Comment i-251 and i-252

Reflections on darshan_13_0917 proposed fixes for i-251 and i-252

Corrected fixes for i-251 and i-252

Figure 145B–11 illustrates a PSE implementing CC_DET_SEQ=3 when the connection check result is dual.

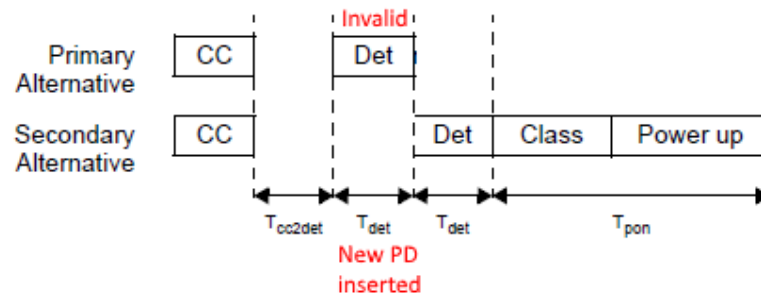
darshan_13_0917 creates the opportunity for a failed detection on the primary pairset to be followed by a successful detection and power-on on the secondary pairset. This will allow T_{pon} violations. T_{pon} violations may occur as do_detect_pri , even if invalid, can take up to 500ms, during which time the object connected to PSE PI may change.

The entire logic behind moving to an explicit description of the CC/DETECT sequences was to make impossible a PD removal-reinsertion during the entire CC-DETECT-CLASS-POWER sequences 0, 1, 2 and 3 for both single and dual signature PDs. Instead of allowing the secondary to power on after the primary has failed (and is in WAIT_PRI) we must instead require a new Connection Check.

Modify Figure 145-15 to add sism term IDLE_PRI entry and allow pse_reset_pri

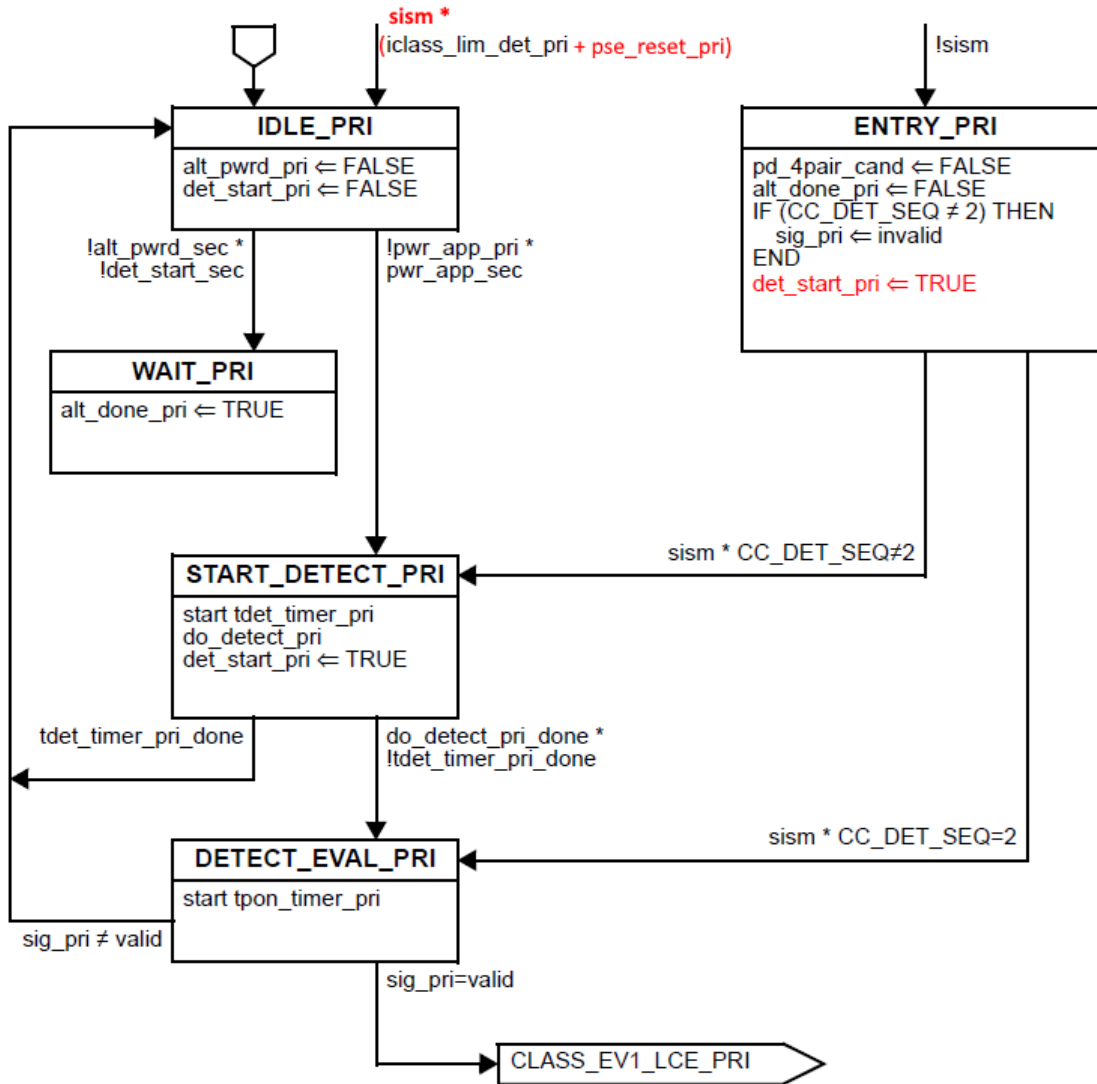
If Primary fails to powerup, the Primary state machine returns back to IDLE_PRI. As a result, pwr_app_pri variable will remain in FALSE, and the secondary state machine won't be able to exit from ENTRY_SEC i.e. will be stuck there.

When class_4PID_multi_events_sec=FALSE, and CC_DET_SEQ=0 is TRUE or CC_DET_SEQ=1 is TRUE, If START_DET_PRI exit to IDLE_PRI due to tdet_timer_pri_done, the pwr_app_pri will remain in FALSE which won't allow exiting from ENTRY_SEC to START_DETECT_SEC and the secondary state machine remain stuck in ENTRY_SEC.

Note: Even if we did detection before tdet_timer_pri is expired, we will get tdet_timer_pri_done anyway at some time. There is missing stop timer assignment.
